PUBLIC INTEREST REVIEW FOR GROUND WATER APPLICATIONS

SUBJECT: Application G- 17273 Supersedes review of _____
Date of Review(s)

A. GENERAL INFORMATION: Applicant's Name: Wayne Bean County: Morrow

Ground Water Application G-17273, Bean Morrow County, Boardman Quad

**OWRD LOGID MORR 791
 04N/25E-14CC**

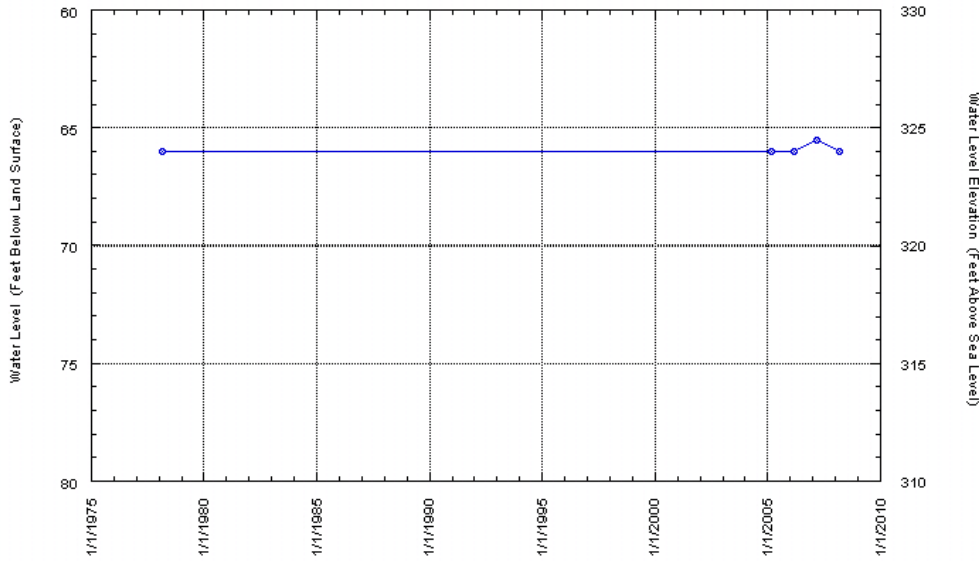
Lithology: basalt
 Aquifer: CRBG
 Land surface elevation: 390'
 Well Depth: 107'
